**AGENDA**  
**CITY OF CEDAR FALLS, IOWA**  
**PLANNING AND ZONING COMMISSION**  
**WEDNESDAY, JULY 11, 2018**  
**5:30 PM AT CITY HALL - COUNCIL CHAMBERS**

**A. College Hill Neighborhood District Site Plan Review – 2119 College Street, 1015-1021 West 22nd Street**

RE: 2119 College Street Site Plan: Staff questions and comments to Commissioners

RE: 2119 College Street Site Plan Review Comments

1 COLLEGE HILL RELATIVE ELEVATIONS 1

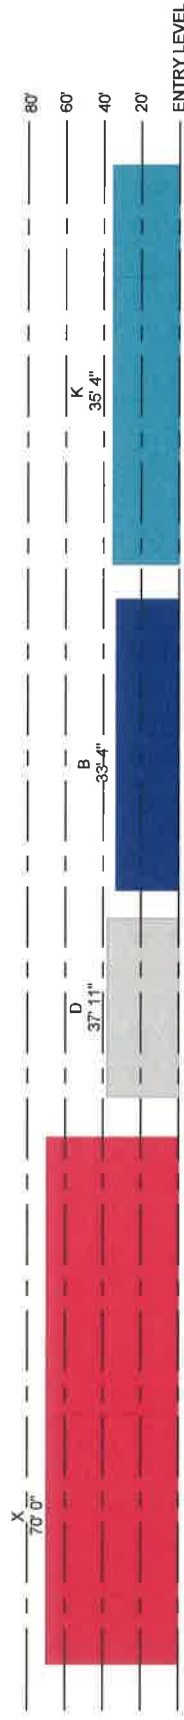
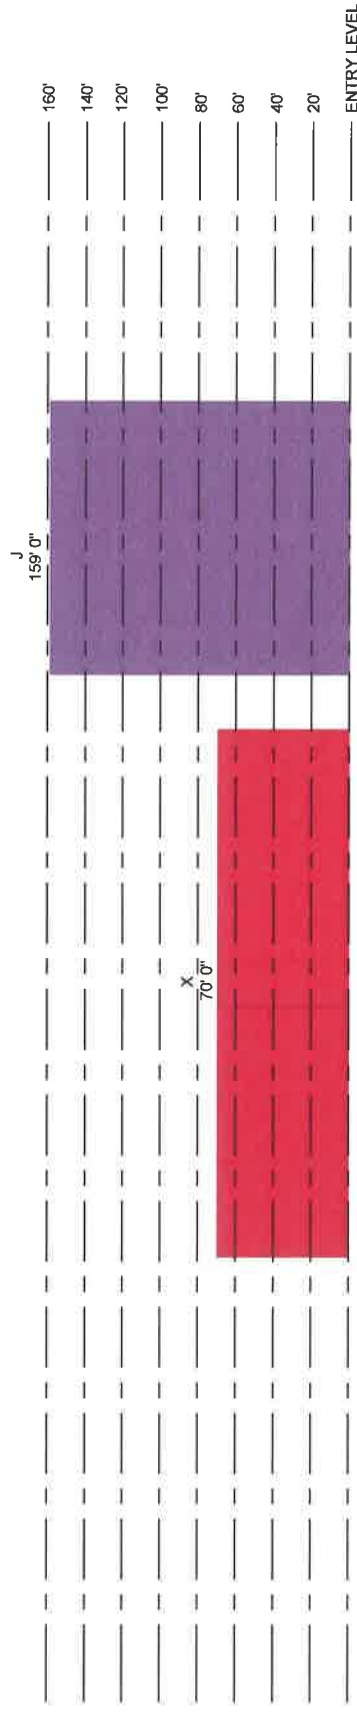
To evaluate how tall this proposed building will actually look, we have commissioned review of prior site plans and the current site plans of 2119 College by Studio 192 and Co in Des Moines, Iowa and Dirk Westercamp. He is a registered architect in Iowa, Minnesota, Illinois, South Dakota, and Kansas.

Mr. Westercamp focused not only on the height of the building structure, but its relative height which takes into account ground elevation as well as height of the structure. His diagrams are attached hereto. As previously mentioned, certain of these worked off of prior site plans. Mr. Westercamp believes that the heights and comparisons in his report are still accurate and the heights may be even larger than previously suspected.
